LIDAR Quality Report

LA_Catahoula_Concordia_1_2017

2021-01-12

Fig	ure	2

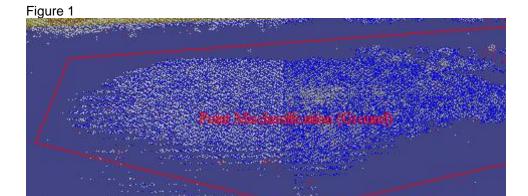
Deliverable	Error Type	Subtype	Quantity	Examples
Classified Pointcloud	Point Mis-classification	Ground	1	Figure 1
Error Comment(s): A	n island is classified as	water in the lidar point c	loud	
Classified Pointcloud	Point Properties	Intensity	1	Figure 2
Error Comment(s): 82 las files have suspect intensity values				
Classified Pointcloud	Processing	Other	1	
Error Comment(s): 2 lpc tiles are missing from the work unit. "15RXQ3959", "15RXQ4476"

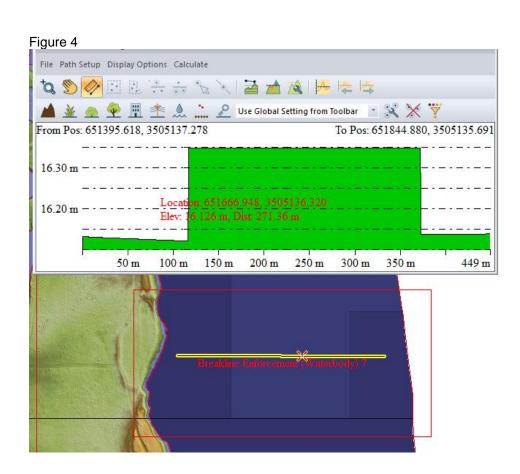
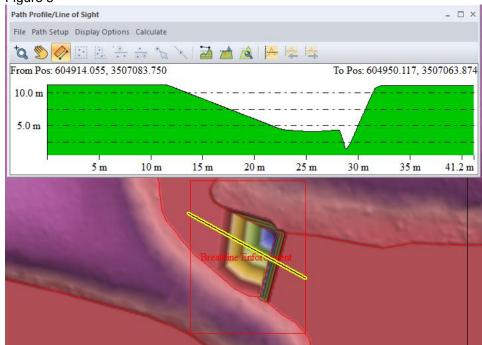
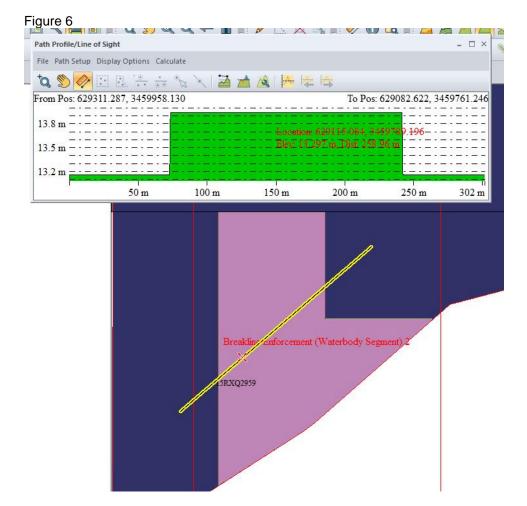
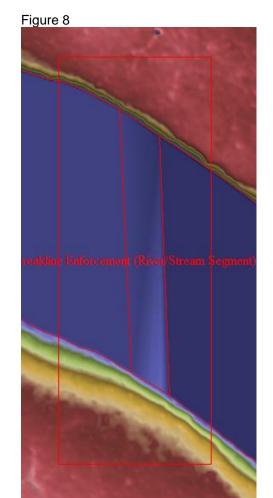
Deliverable	Error Type	Subtype	Quantity	Examples
DEM	Breakline Enforcement	None	10	Figure 3 Figure 4
Error Comment(s): 1. Large segment of coastline has breakline enforcement issues 2. Large segment of coastline is missing breakline enforcement 3. A pit is present in a waterbody in the DEM 4. A segment of waterbody is missing breakline enforcement 5. A segment of river is partially missing breakline enforcement 6. A waterbody is missing breakline enforcement 7. A segment of river has an enforcement error due to breaklines 8. A segment of river is missing breakline enforcement likely due to misplaced breaklines 9. A segment of river is missing breakline enforcement likely due to misplaced breaklines 10. A segment of waterbody is missing breakline enforcement likely due to misplaced breaklines			Figure 5 Figure 6 Figure 7 Figure 8 Figure 9 Figure 10	
DEM	DEM Properties	NoData Value	1	Figure 11

Figure 13

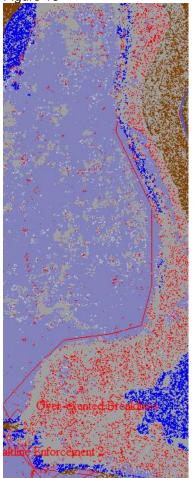
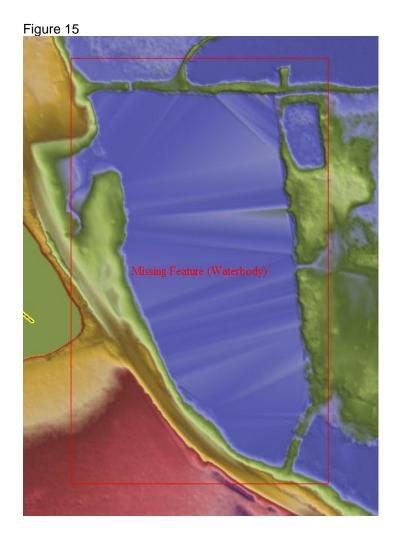
Hydroflattened Polygon Breaklines	Geometry Error	Overextended	1	Figure 13
Error Comment(s): A	waterbody's breaklines	over-extend water and	reach land	
Hydroflattened Polygon Breaklines	Missing Feature	Waterbody	5	Figure 14 Figure 15
Error Comment(s): 1. A waterbody is present and missing breaklines 2. A waterbody is present in the DEM and missing breaklines 3. A waterbody present in the DEM is missing breaklines 4. A waterbody present in the DEM is missing breaklines 5. A waterbody is missing breaklines			Figure 16	
Hydroflattened Polygon Breaklines	Geometry Error	River/Stream Segment	2	Figure 17 Figure 18
Error Comment(s): 1. A segment of river h 2. A segment of river h				
Hydroflattened Polygon Breaklines	Geometry Error	None	2	Figure 19 Figure 20
Error Comment(s): 1. Breaklines have been misplaced and causing a breakline enforcement issue in the river 2. Breaklines have been misplaced and causing a breakline enforcement error
